Groundwater Transfer Review Summary Form

Transfer/PA # T- 14799

Ground Water Review Form:

Application: T-14799

Figure 1. Well location Map

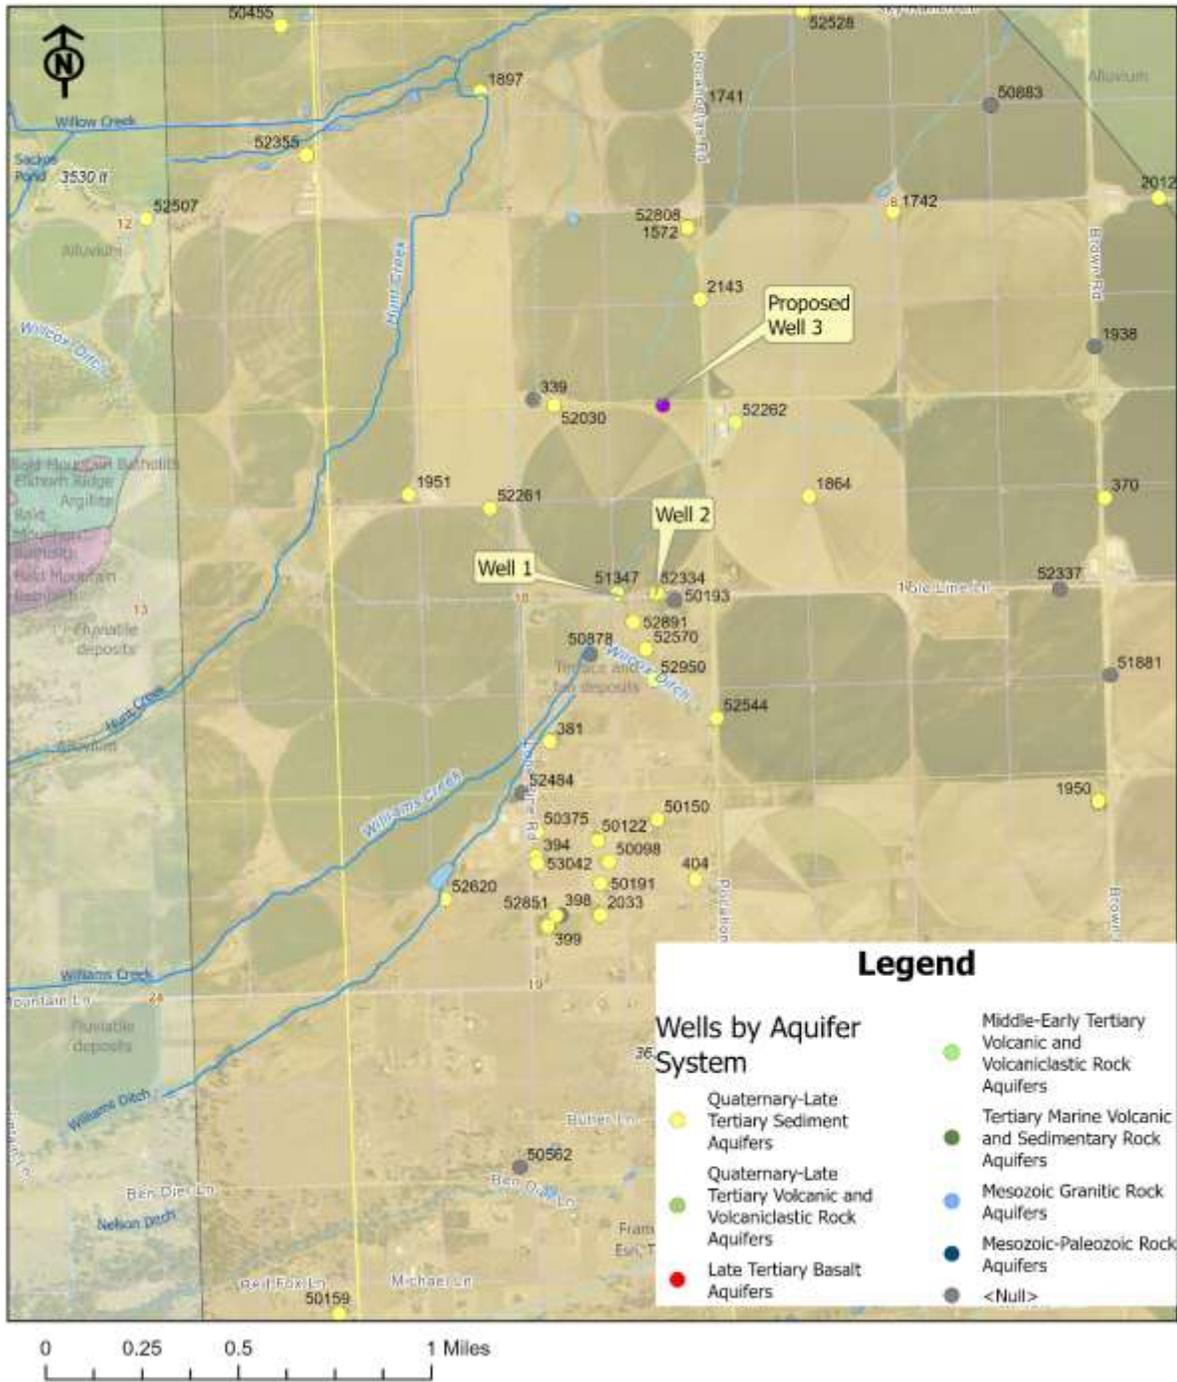
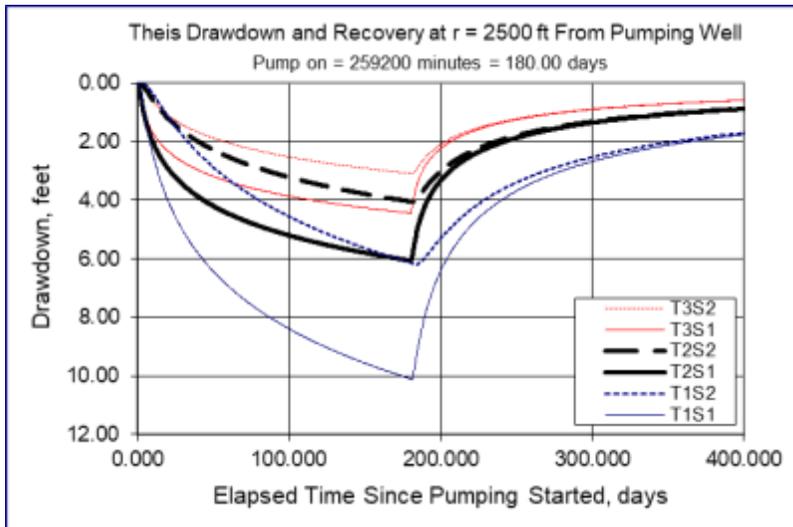
5. a) Will this proposed change, at its maximum allowed rate of use, likely result in an increase in interference with **another ground water right**?
 Yes No Comments: The largest change in proximity to other wells is between the proposed well and BAKE 52265. The proposed well would be approximately 1,000 feet from BAKE 52262, while current POA BAKE 52334 is 2,500 feet from the same well.

Figure 2. Distance-drawdown estimates, using aquifer parameters from pump testing at BAKE 52262 show a maximum increase in well-to-well interference drawdown of 6 feet. The proposed well is 1,000 feet from the neighboring well, while the existing wells are a minimum of 2,500 feet away.

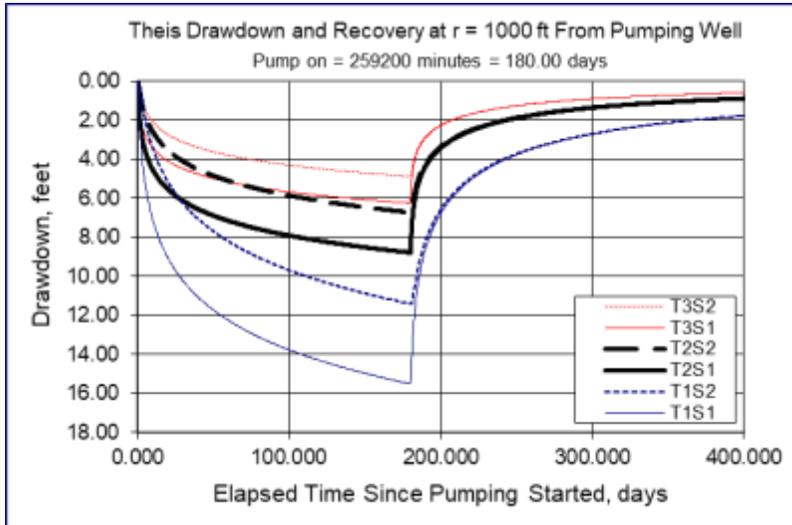
- b) If yes, would this proposed change, at its maximum allowed rate of use, likely result in another groundwater right not receiving the water to which it is legally entitled?
 Yes No If yes, explain: At 2,500 feet away, pumping 1.95 cfs for 180 days from BAKE 52334 will create up to 7 feet of drawdown at BAKE 52265. Moving that pumping to the proposed POA, 1,000 feet from BAKE 52265, will create up to 10 feet of drawdown. This increase of 3 feet will not prevent access to groundwater; the wells are greater than 500 feet deep, with less than 50 feet below land surface to the static water level, meaning there are at least 450 feet of water in the wells.

Figure 3a. Estimated stream depletion from existing pumping at BAKE 51347, using aquifer parameters from single well testing at BAKE 52262, show ...

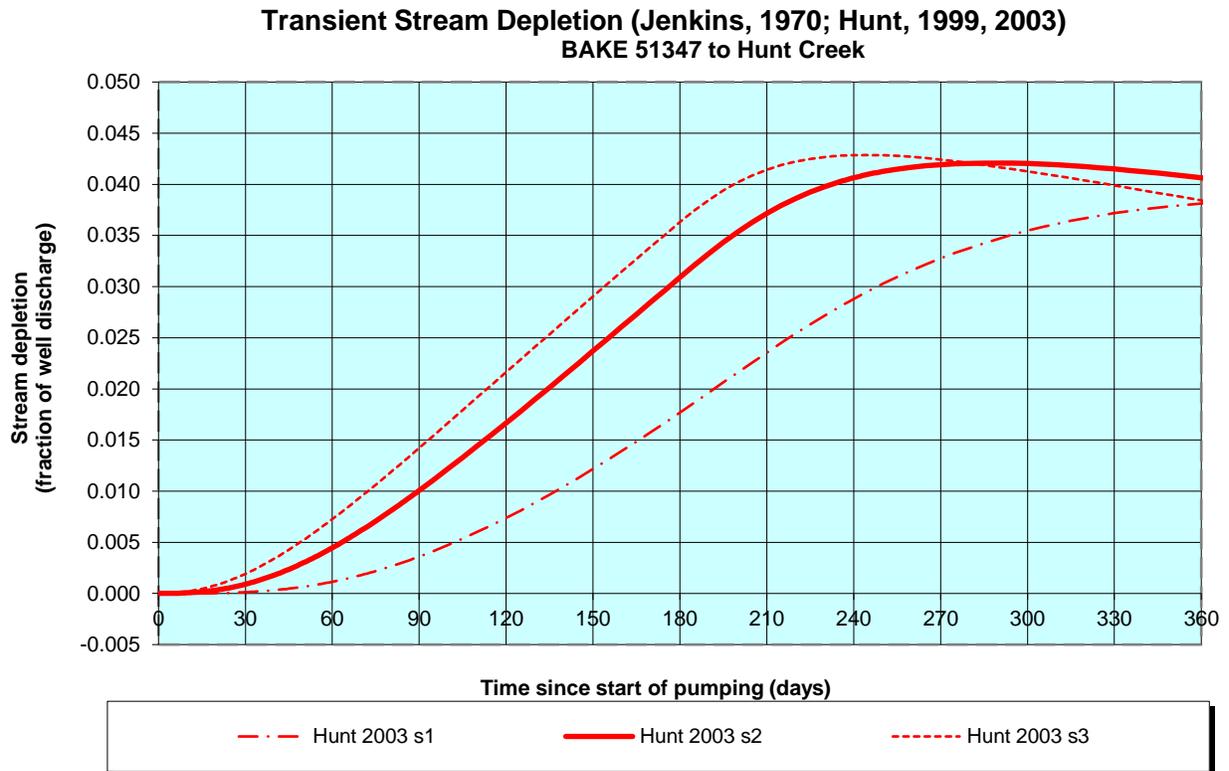
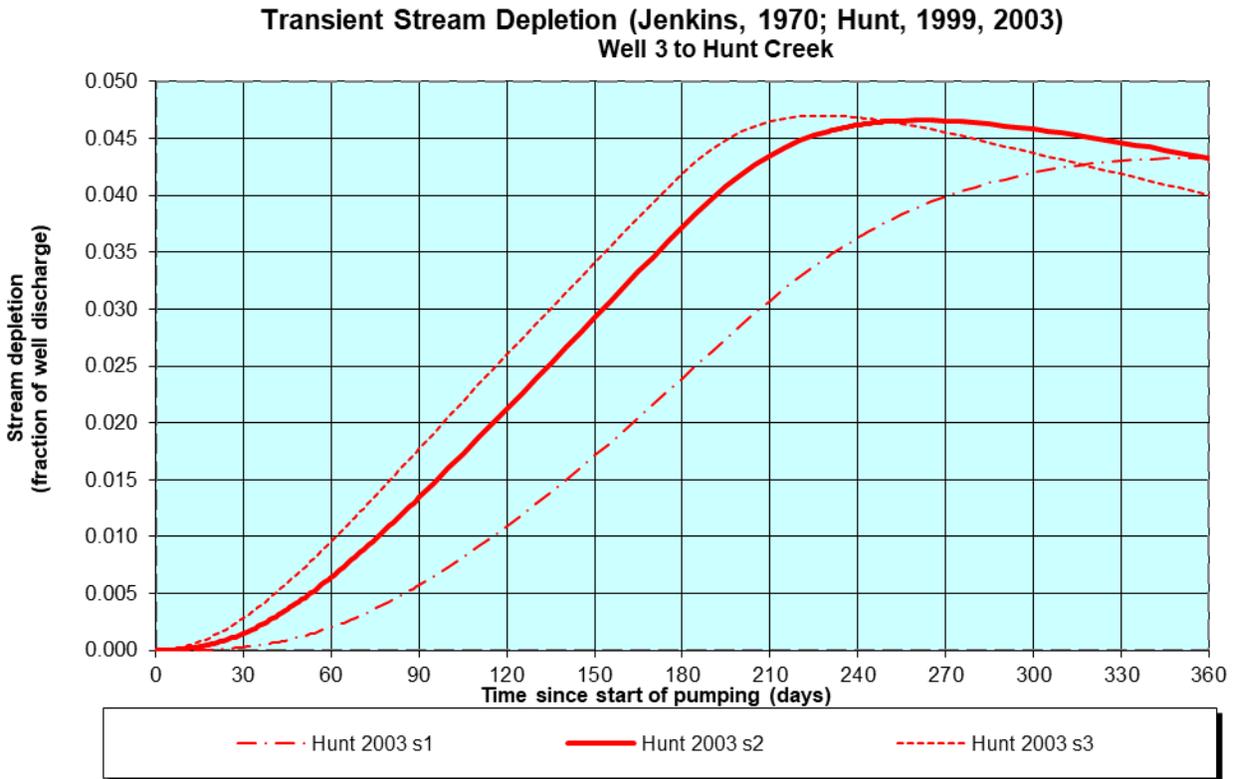
6. a) Will this proposed change, at its maximum allowed rate of use, likely result in an increase in interference with **another surface water source**?
 Yes No Comments: The proposed POA, Well 3, is approximately 400 feet closer to Hunt Creek than the authorized wells. This will result in an increase in interference with Hunt Creek.

- b) If yes, at its maximum allowed rate of use, what is the expected change in degree of interference with any **surface water sources** resulting from the proposed change?
Stream: Hunt Creek Minimal Significant
Stream: _____ Minimal Significant
Provide context for minimal/significant impact: As shown in Figure 3, the increase in stream depletion is less than 0.1% (< 1 gallon per minute) of the pumping rate after 365 days.
